IEEE P802.15
Wireless Personal Area Networks

Project	IEEE P802.15 Working Group for Wireless Personal Area Networks (WPANs)	
Title	TG3 D10 running comment resolutions	
Date Submitted	[8 July, 2002]	
Source	[James P. K. Gilb] [Apparent Technologies] [9921 Carmel Mountain Rd. #247, San Diego, CA 92129]	Voice: [858-538-3903] Fax: [858-538-3903] E-mail: [gilb@ieee.org]
Re:	[]	
Abstract	[This document is a record of comment resolutions for LB17.]	
Purpose	[To provide a record of the comment resolution for LB17.]	
Notice	This document has been prepared to assist the IEEE P802.15. It is offered as a basis for discussion and is not binding on the contributing individual(s) or organization(s). The material in this document is subject to change in form and content after further study. The contributor(s) reserve(s) the right to add, amend or withdraw material contained herein.	
Release	The contributor acknowledges and accepts that this contribution becomes the property of IEEE and may be made publicly available by P802.15.

1. Comment resolution in Schaumburg

Figure 16—Source DEV-2 Terminating its stream

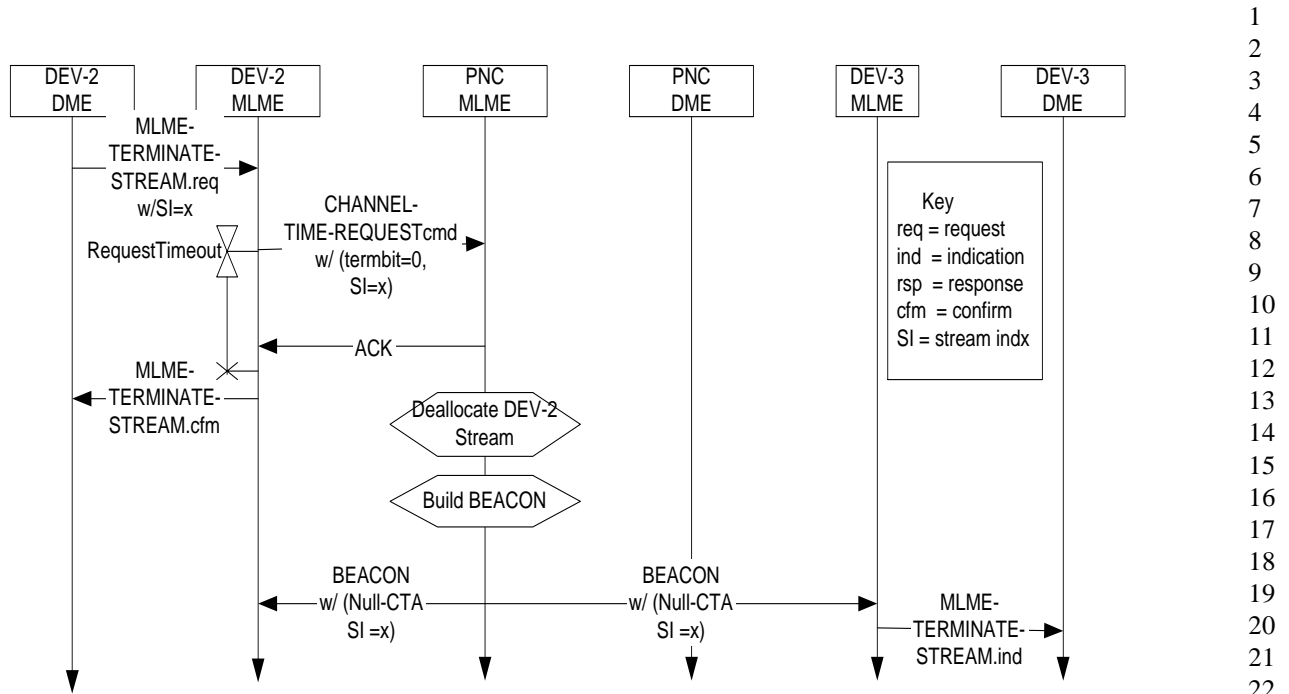
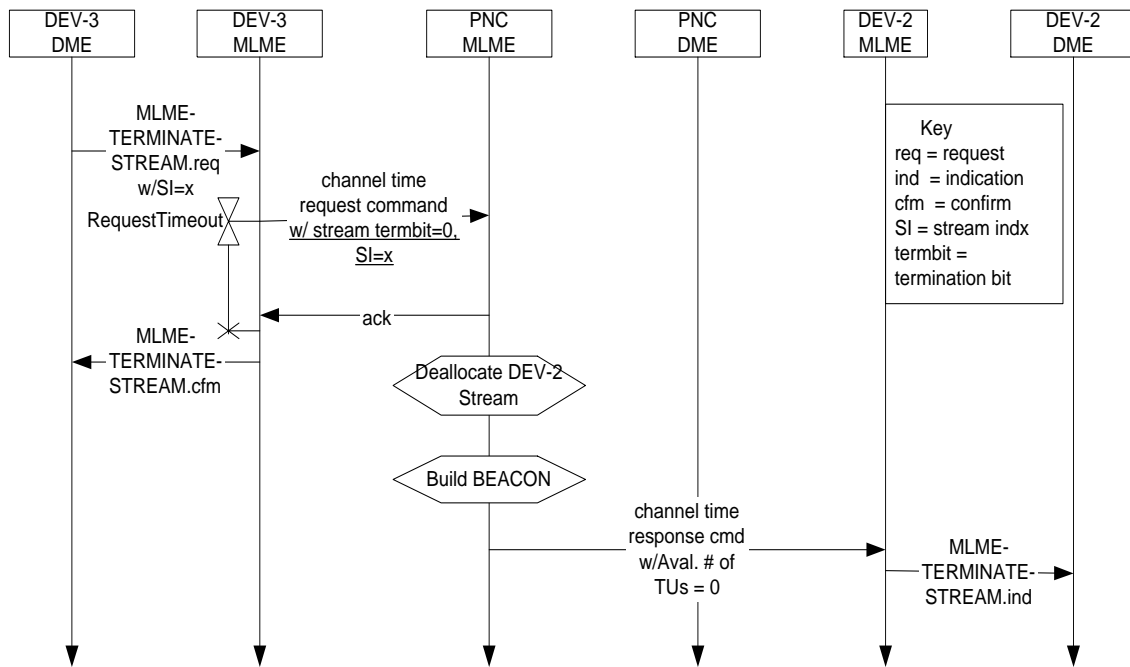
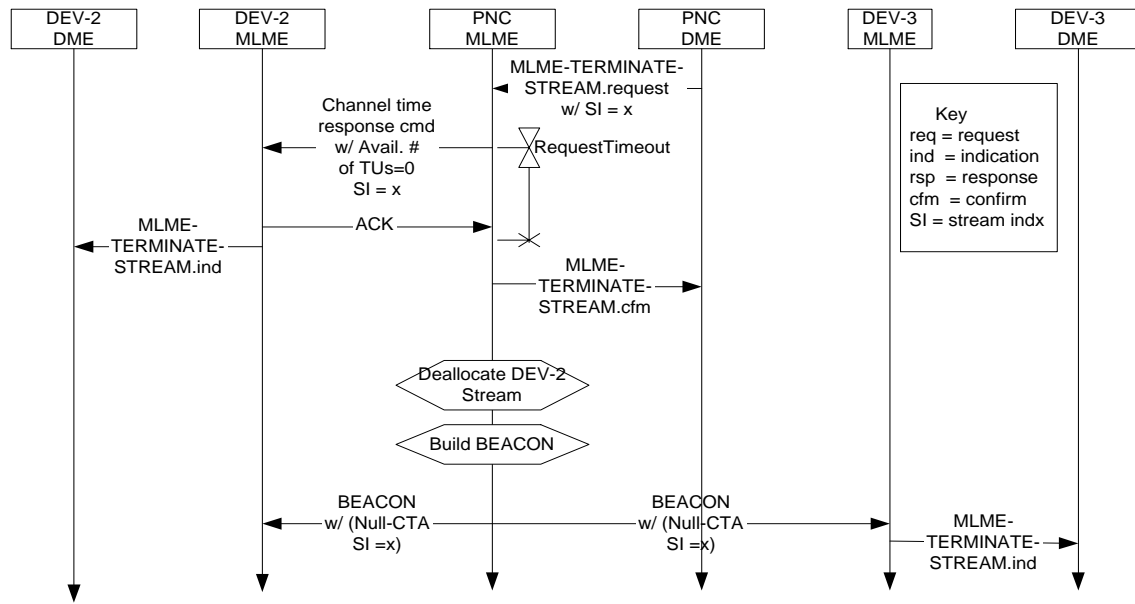
907 (Bain,TR) Grammatical errors and reference to figure 118 is incorrect and does not pertain to text in this section. Consequently, change the paragraph to the following: "In the case where the PNC wishes to terminate the stream, it shall notify the originating DEV and the target DEV via the next periodic beacon that the CTAs assigned to the indicated stream index are set to a null CTA value for aMinBeaconInfoRepeat duration." **Suggest reject** pending acceptance of CID 364

The PNC, upon receiving a channel time request command from a DEV requesting stream termination, shall respond with an ACK. In the case where the stream originating DEV is requesting a stream termination, the PNC shall then notify the target DEV of the termination via a null CTA in the beacon for {xref aMinBeaconInfoRepeat} duration. For CTAs that were not allocated every beacon, e.g. subrate slots, the null CTAs shall be placed starting in the beacon where the next CTA would have occurred and in the following {xref aMinBeaconInfoRepeat}-1 beacons. A null CTA has the stream index, SrcID and DestID with zero values for the slot location and slot duration, {xref 7.4.8}. {xref Figure 16} illustrates the MSC for termination of a stream by a source DEV. In the case where the target DEV is requesting a stream termination, the PNC shall then notify the stream originating DEV of the termination via a channel time response command. {xref Figure 17} illustrates the MSC for termination of a stream by a target DEV.

In the case where the PNC decides to terminate a stream originating DEV's stream, the PNC shall notify the source DEV via a channel time response command and the target DEV via a null CTA in the beacon for aMinBeaconInfoRepeat duration. For CTAs that were not allocated every beacon, e.g. subrate slots, the null CTAs shall be placed starting in the beacon where the next CTA would have occurred and in the following {xref aMinBeaconInfoRepeat}-1 beacons. {xref Figure 18} illustrates the termination of a source DEV's stream by the PNC.

Resolution is to reject, "Figure 118 has been removed, a new termination procedure in 02/273r13 describes with correct MSCs the procedure."

Figure 21—MSC for the initiating of a neighbor piconet.

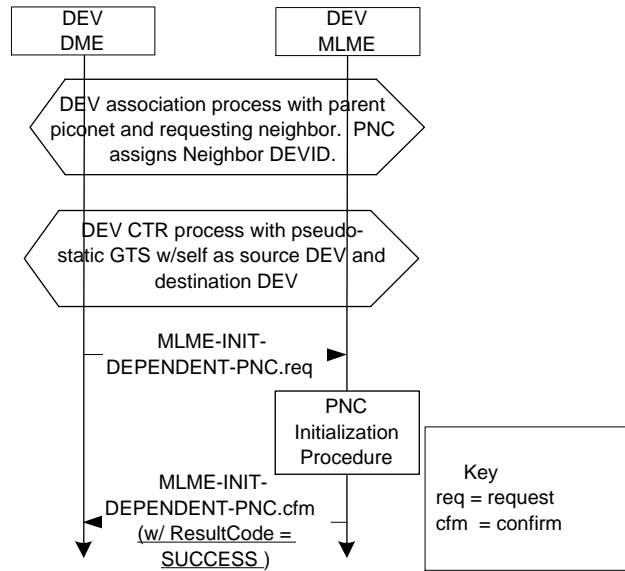
179 (Heberling, TR) - Figure 98 should be replaced with a proper MSC of the required protocol needed to establish a neighbor piconet. Replace figure 98 with a proper MSC. **Suggest accept** - An MSC for neighbor piconet initialization is included below. It needs twiddling to get the vertical lines to not show in the hex pro-

cess blocks. Also, although consistent with other similar diagrams, this MSC seems to need the first beacon of the neighbor PNC shown.

The MSC for the initiation of the neighbor piconet is illustrated in Figure 21.

Accept in principle, “Accept suggested resolution but add a line at the bottom that shows the first beacon being sent. Also add after the sentence that says ‘The MSC for the initiation a neighbor piconet is illustrated in Figure 21.’ the following sentence, ‘The association and channel time request processes are defined in xref and xref, respectively.’”

Figure 22—MSC for the creating a child piconet.

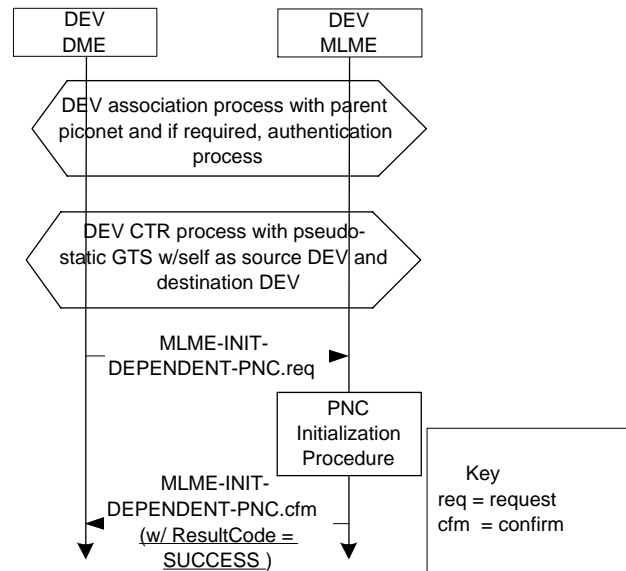
177 (Heberling, TR) - Figure 96 should be replaced with a proper MSC of the required protocol needed to establish a child piconet. Replace figure 96 with a proper MSC. **Suggest accept** 'An MSC for child piconet initialization is included below. It needs twiddling to get the vertical lines to not show in the hex process blocks. Also, although consistent with other similar diagrams, this MSC seems to need the first beacon of the child PNC shown.

The MSC for creating a child piconet is illustrated in Figure 22.

Accept suggested resolution but add a line at the bottom that shows the first beacon being sent. Also add after the sentence that says 'The MSC for creating a child piconet is illustrated in Figure 22.' the following sentence, 'The association and channel time request processes are defined in xref and xref, respectively.'

Figure 23—MSC for a approved asynchronous channel time request

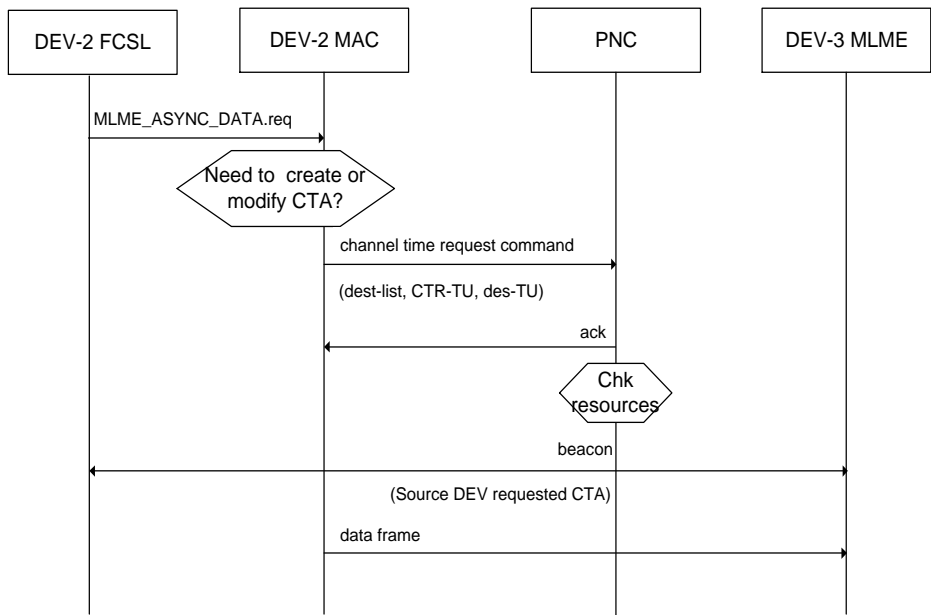
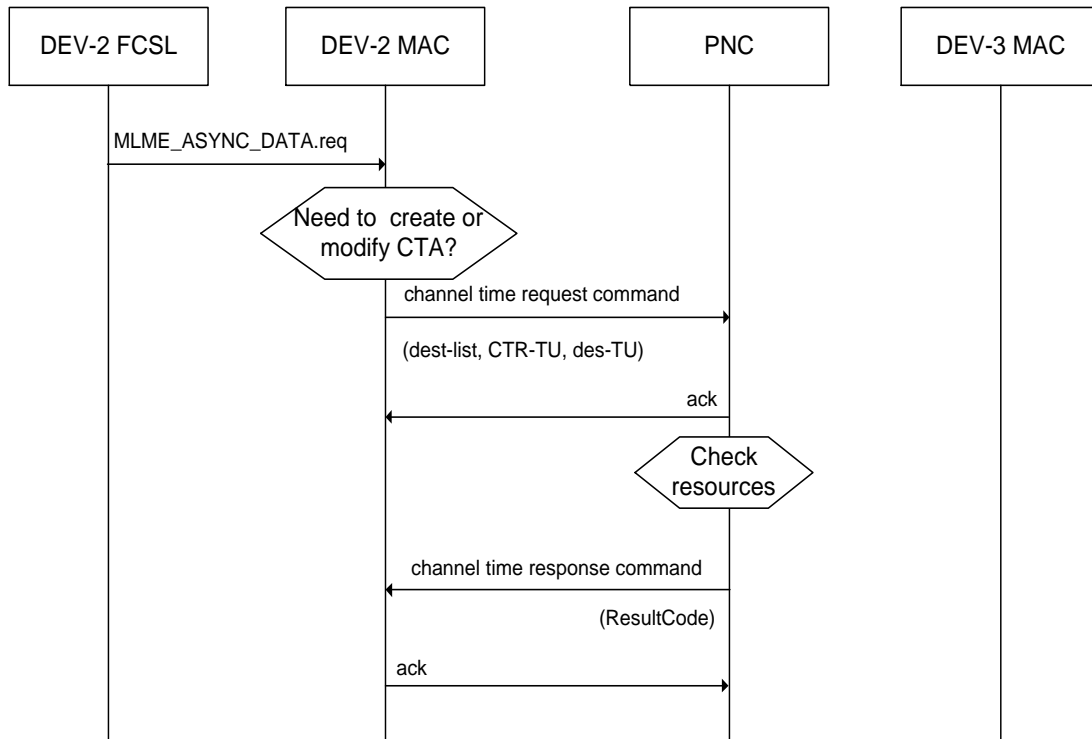
<Page 182, Figure 119> – MSC for reserving asynchronous data channel time. Discussed earlier, new MSC is below (needs work to match the other MSCs in the clause.):
